# COPLEY TOWNSHIP STAFF REPORT

## APPLICANT SUMMARY

PROJECT:	APPLICATION TYPE: Site Review
LANDOWNER	Joel Stile, Heritage Woods, LLC.
APPLICANT	Patricia Rokoci, Director of Development (Redwood)
COMPANY PERFORMING WORK REQUESTED	Redwood
INVESTMENT	\$10,000,000
APPLICATION SUMMARY	<p>The applicant has submitted a concept plan which would develop a vacant parcel (15-08335) located off Ridgewood Rd. which consists of 58.2 acres. The land is located within the Planned Development District (PDD) and is subject to a Settlement Agreement which was recorded on December 18, 2013 which limited the overall number of development units on the remaining vacant land. Based upon this Agreement, 145 units are permitted. Redwood has proposed to construct 100 slab-on-grade units. The development would be solely owned, managed and operated by Redwood who specializes in high-end rental neighborhoods. The proposed units would range in size from 1,294sf to 1,381sf and would be market rate (\$1,600-\$1,700 monthly). Each unit would consist of 2 bedrooms and 2 full baths along with stainless steel appliances, granite countertops, maple cabinets, vaulted ceilings and an open floor plan. The site would be

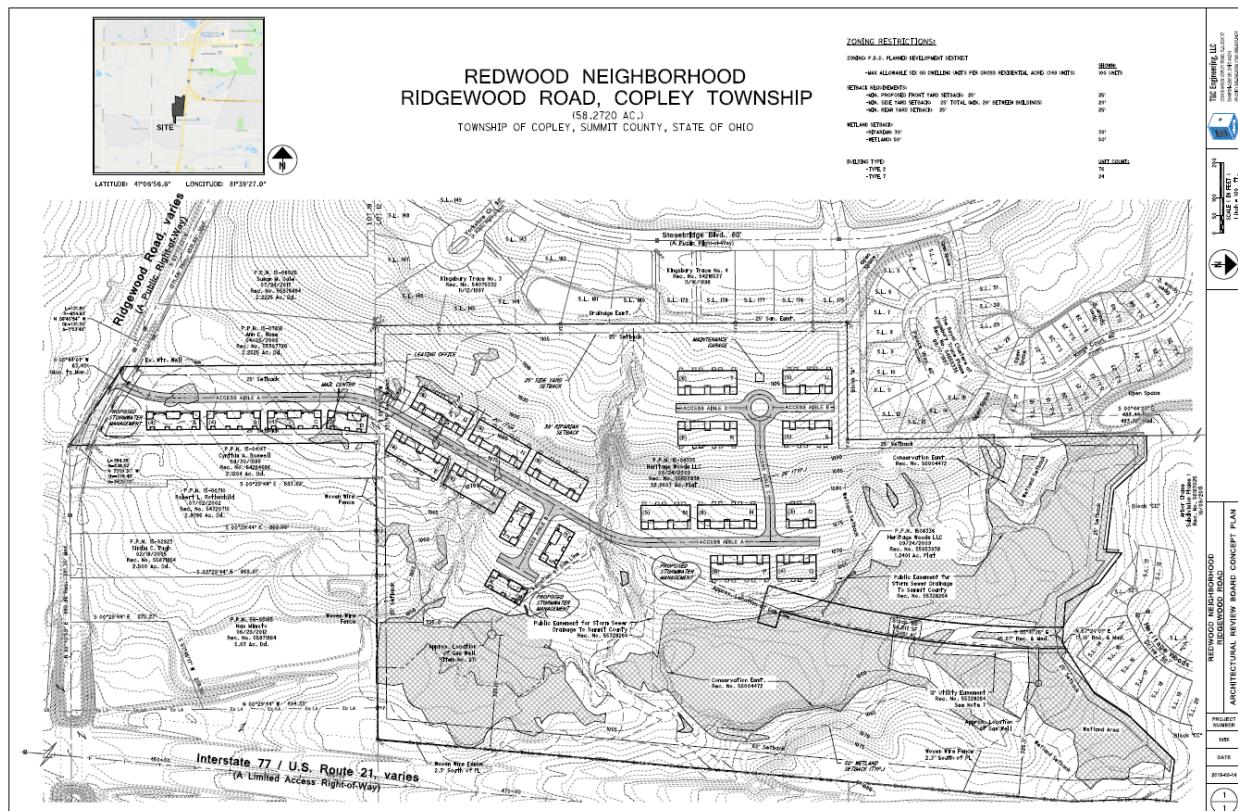
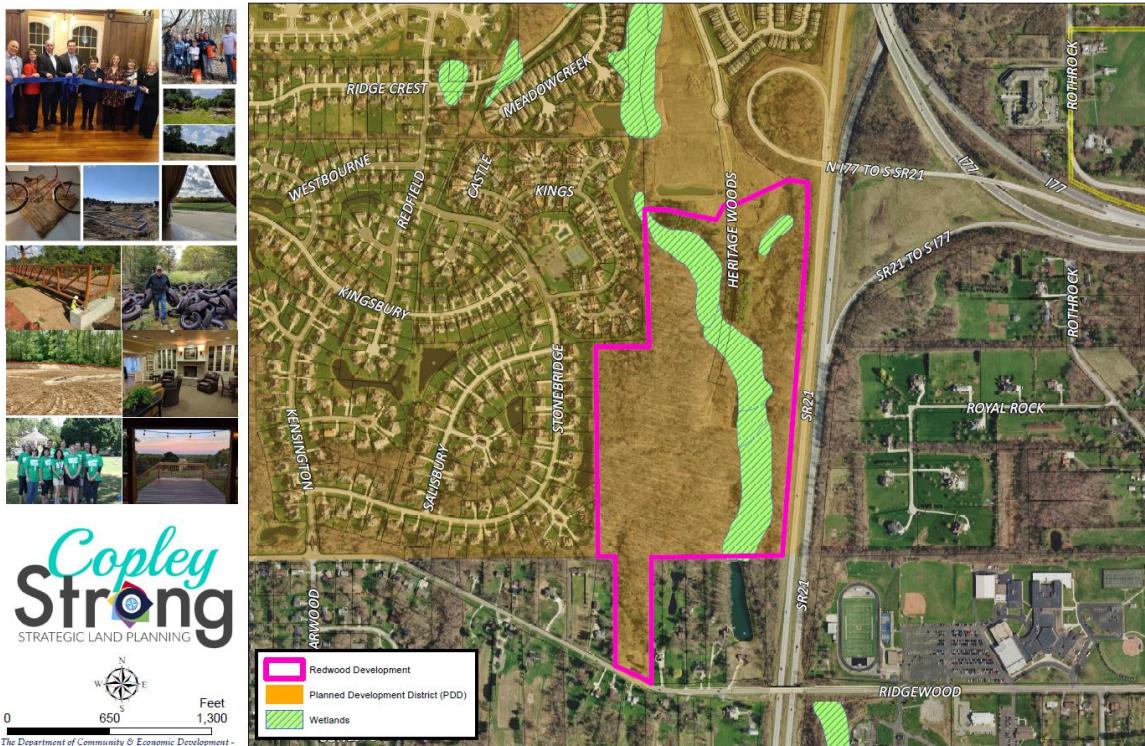
- The site is served by a private access road which will remain the full responsibility of the owner (Redwood) to manage and maintain in perpetuity. Access will be limited to Ridgewood Rd. which is a County roadway consisting of a 65' foot right-of-way. The Engineer's office has requested a Traffic Impact Assessment (TIA) be provided for evaluation.
- Request to have sidewalks and/or a shared use path for the proposed development.

- The site is one of the last remaining undeveloped parcels within the Planned Development District (PDD). As a result, most land surrounding the property has already been developed with primarily single-family residential units.
- Request to explore the possibility of relocating buildings 1 & 2 (8 units total) so as to minimize impact to existing eastern property owner (Cynthia Boswell). Relocated units could be repositioned onsite to have a lesser impact to surrounding property owners.
- Requesting relocation of proposed Maintenance Garage to a more discrete location. Consider relocating to end of Access Aisle D.

- Request tree removal boundary be defined along with preventative measures to protect trees from undercut and critical root zone damage. Past practice has included the installation of fencing or silt fence materials to delineate clearing limits.
- Request an extensive landscaping and buffering plan be submitted for ARB review and approval so as to minimize any visual or screening deficiencies which are lost due to land development.
- Request street tree planting which is compatible with standards from Article 14 – Landscaping and Buffering (individual tree plantings based upon ARB recommendation).
